Comments on Puget Sound Energy's 2017 Integrated Resource Plan

Washington Utilities and Transportation
Commission Docket Nos. UE-160918 & UE-
160919

Prepared for Sierra Club

January 19, 2018

Figure 1. Wind Capital Costs, Lazard Historical and PSE IRP Forecasts

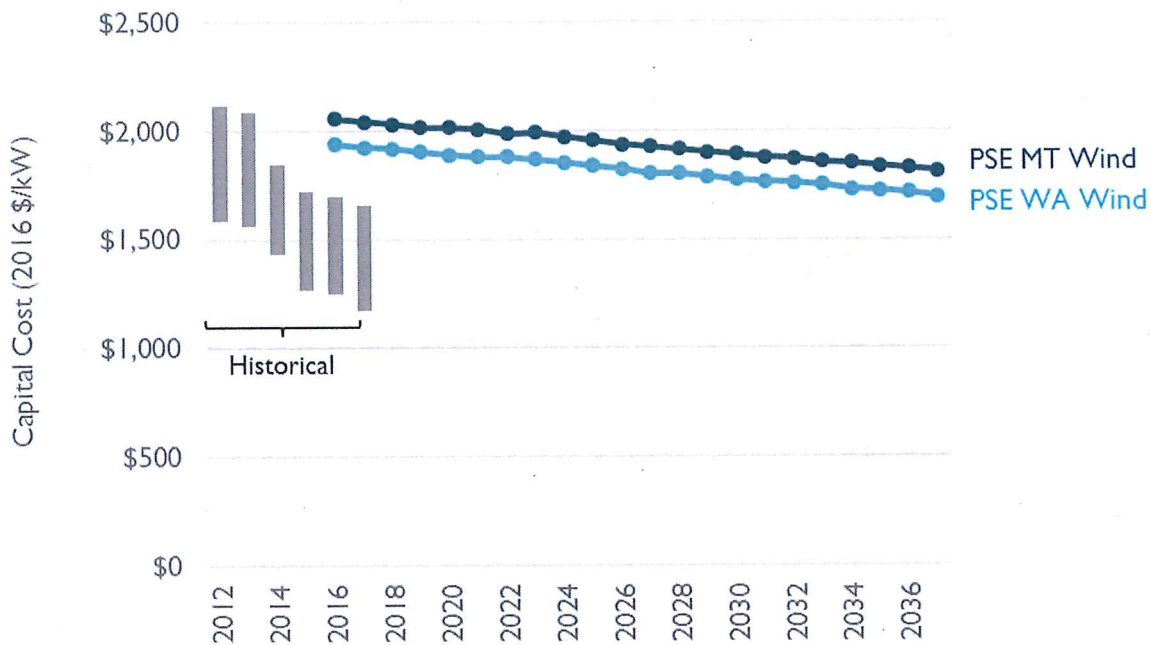
PSE assumes solar and wind capital costs that evidently fail to account for recent cost declines. According to Lazard's annual reports, wind capital costs have declined by about 25 percent over the past five years and solar capital costs have declined by about 50 percent over the same period.¹⁸ Yet PSE's assumed capital cost trajectory indicates that it expects current capital costs consistent with those from about five years ago.

Figure 1 depicts PSE's forecasted capital costs for Washington and Montana wind in comparison to historical Lazard capital cost estimates. This shows that Lazard's estimates of 2017 wind capital costs are 15 percent lower than PSE's Washington wind assumptions and 23 percent lower than PSE's assumptions for Montana wind. Under PSE's projected trajectory, wind capital costs remain above currently achievable levels through 2037.

Figure 2. Solar Capital Costs, Lazard Historical and PSE IRP Forecasts

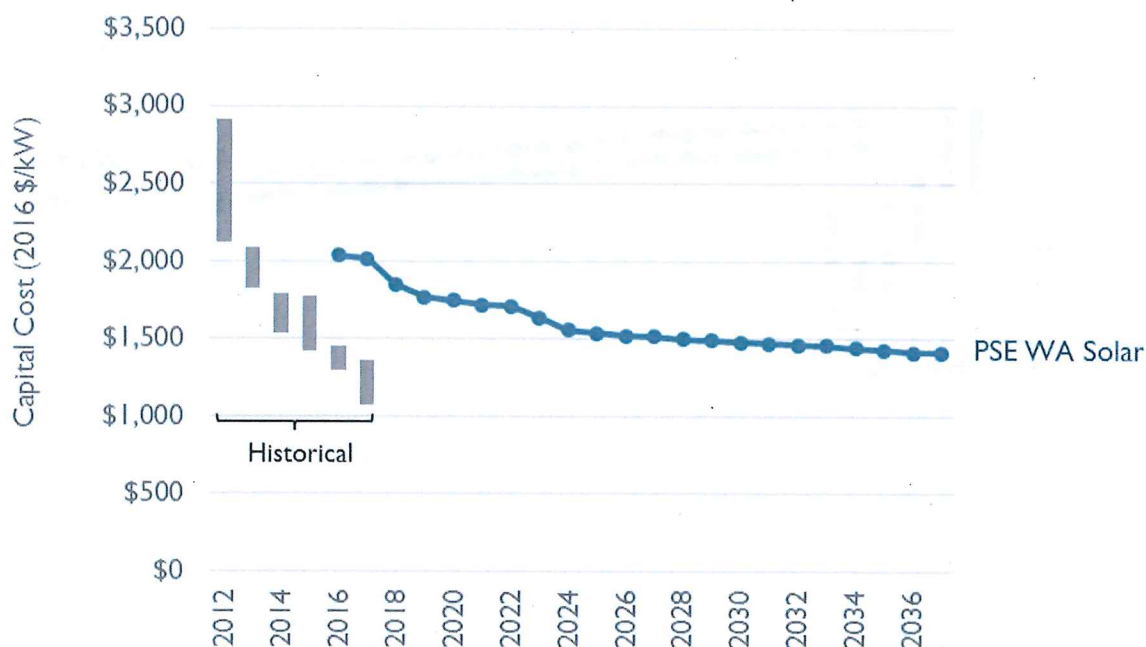
PSE’s solar cost assumptions appear to be even more overstated than its wind costs in the near term. Figure 2 shows that PSE’s cost estimates are about 50 percent too high for 2017. Although PSE forecasts future declines in solar costs, its projection still remains higher than Lazard’s estimate of current costs. Moreover, even PSE’s “lower” solar cost sensitivity assumes capital costs of \$1,755 per kilowatt (kW), about 30 percent higher than current capital costs per Lazard.²¹
